**Addendum 3**

**RALPH AND BETTYE BAILEY HALL - 2012**

Purdue University  
West Lafayette, Indiana

**December 23, 2011**

**Addendum 3**  
 Drawing #: A3-7/S403  
 Date: 12.23.2011  
 Project #: 2010-050.BH1

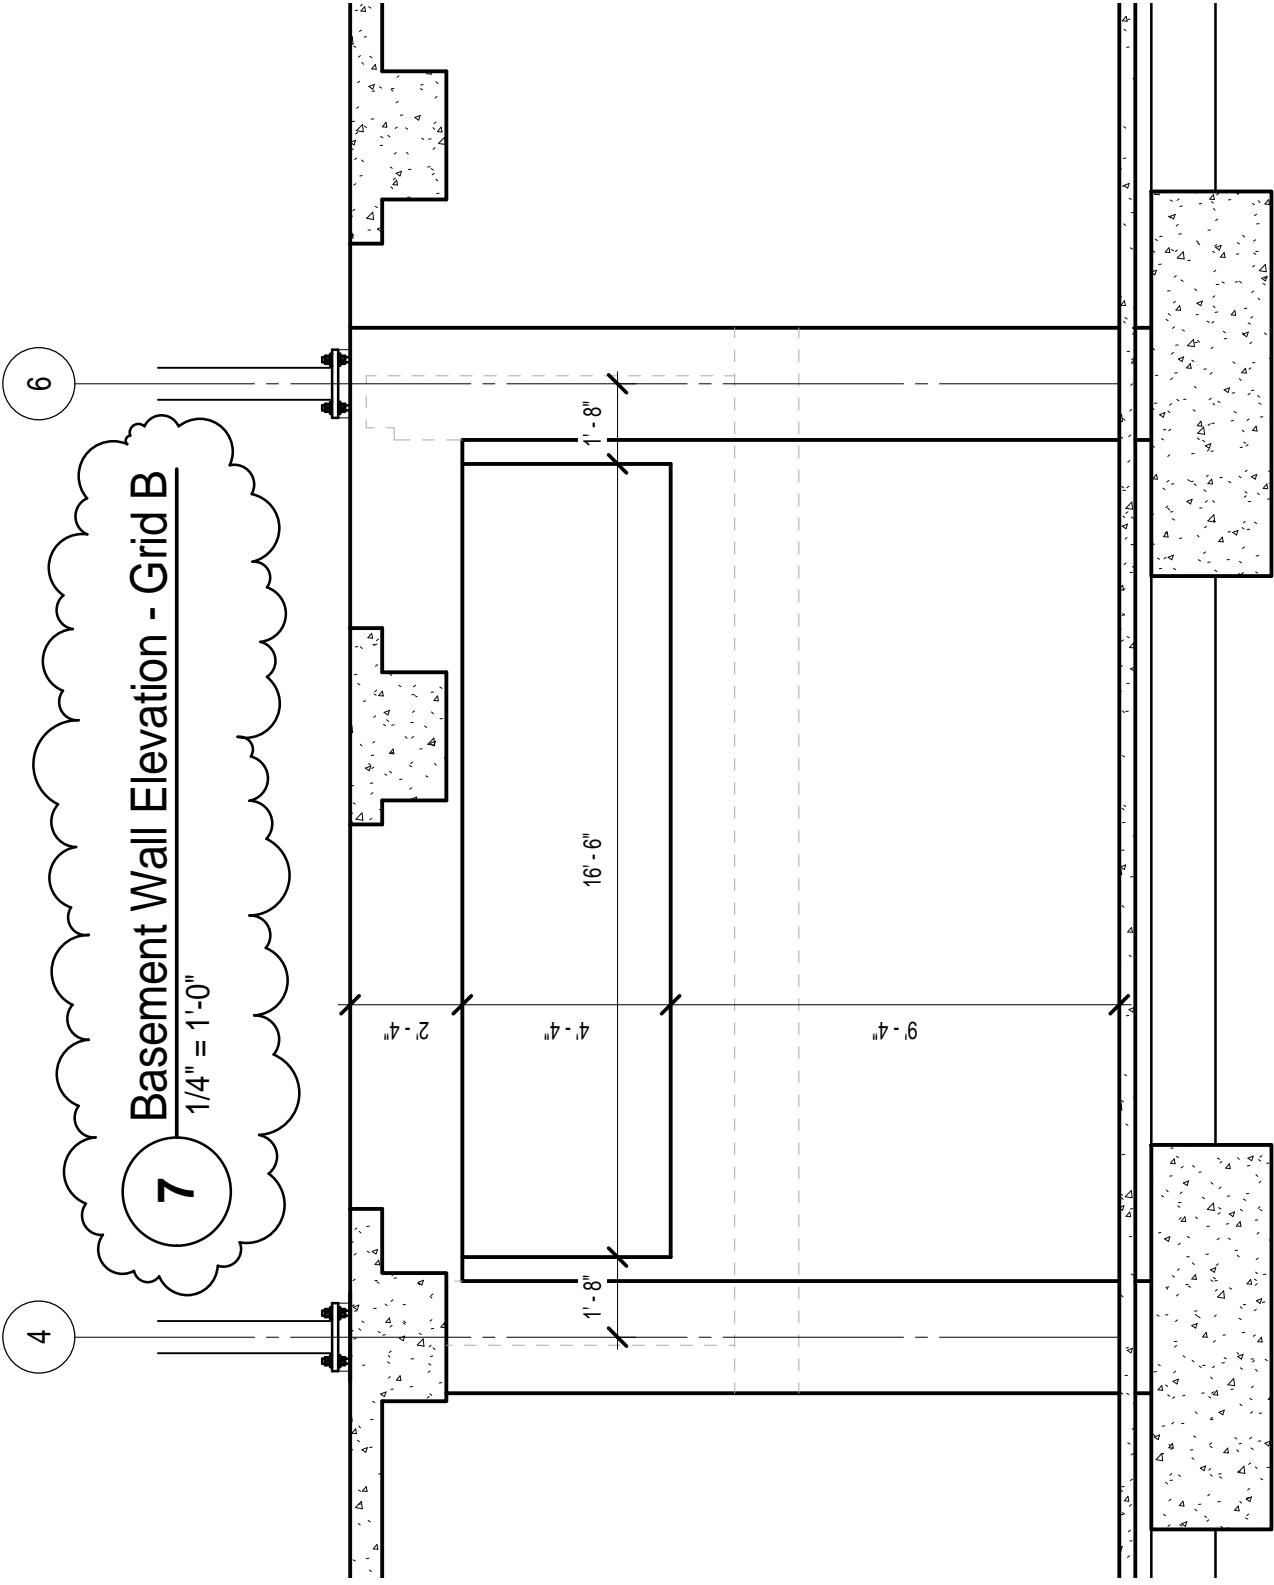
TOP OF MAT FOOTING ELEVATION = -20'-0"  
(G.C. VERIFY w/ ELEVATOR SUPPLIER  
PRIOR TO CONSTRUCTION)
  3. Section 7: Add CONT. WATERSTOP Rx where the slab-on-grade abuts the 12" concrete wall.
- C. S-403
  1. Add Detail 7 BASEMENT WALL ELEVATION - GRID B per attached Drawing A3-7/S403.
- D. S-601
  1. Under COLD-FORMED (LIGHT GAUGE) METAL FRAMING NOTES:
    - a. Revise Note #2 as follows: Change Fy=36 ksi to Fy=33 ksi for 18, 20 gauge members.
    - b. Add Note #27 as follows:
